POLICY REPORT
DEVELOPMENT AND BUILDING

Report Date: September 14, 2015
Contact: Susan Haid
Contact No.: 604.871.6431
RTS No.: 11069
VanRIMS No.: 08-2000-20
Meeting Date: September 29, 2015

TO: Vancouver City Council
FROM: General Manager of Planning and Development Services
SUBJECT: CD-1 Rezoning: 4162 and 4188 Cambie Street

Figure 2: Landscape / Site Plan

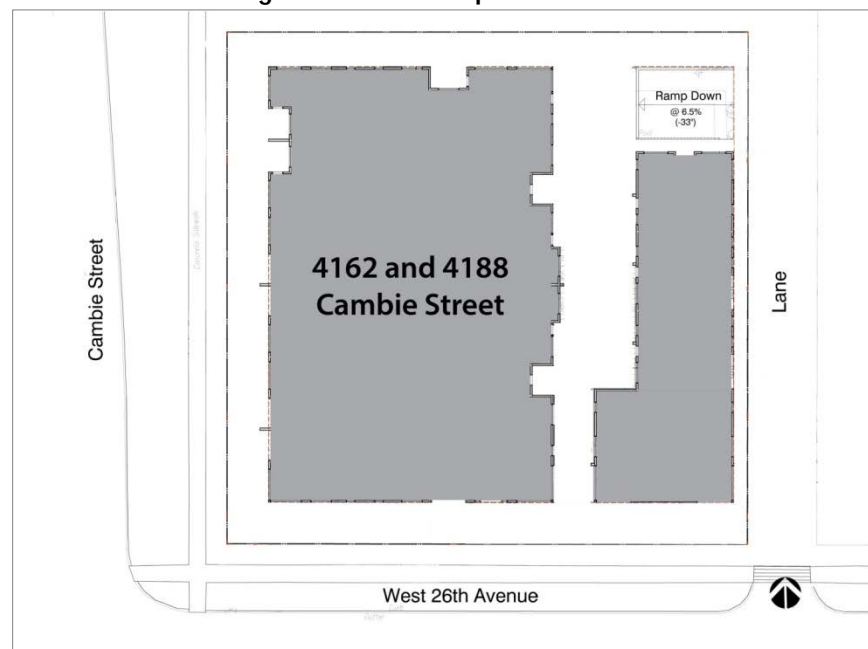
- 1. Design development to improve the quality and functionality of the common courtyard space as follows:
 - (i) Delete the building return at the south end of the townhouse building.
 - (ii) Provide a clear 24 ft. separation for full width of the courtyard from the north to the south property line.
 - (iii) Locate the children's play space within the courtyard space, adjacent the amenity room.

- (iv) Provide additional common outdoor space at the courtyard for children's play and other outdoor activities.

Note to Applicant: The courtyard design should accommodate a variety of opportunities for common use, and not be limited to a path and private patios. Benches should be provided, and small common patio areas or 'pockets' designed to facilitate informal gathering. A more informal and less orthogonal layout for the circulation path is encouraged.

- (v) Provide additional soft landscaping, including trees.
Note to Applicant: Trees may be located to help punctuate or define common sitting areas, as per above.
- (vi) Provide for integration of the entry lobby, amenity room and adjacent outdoor space.
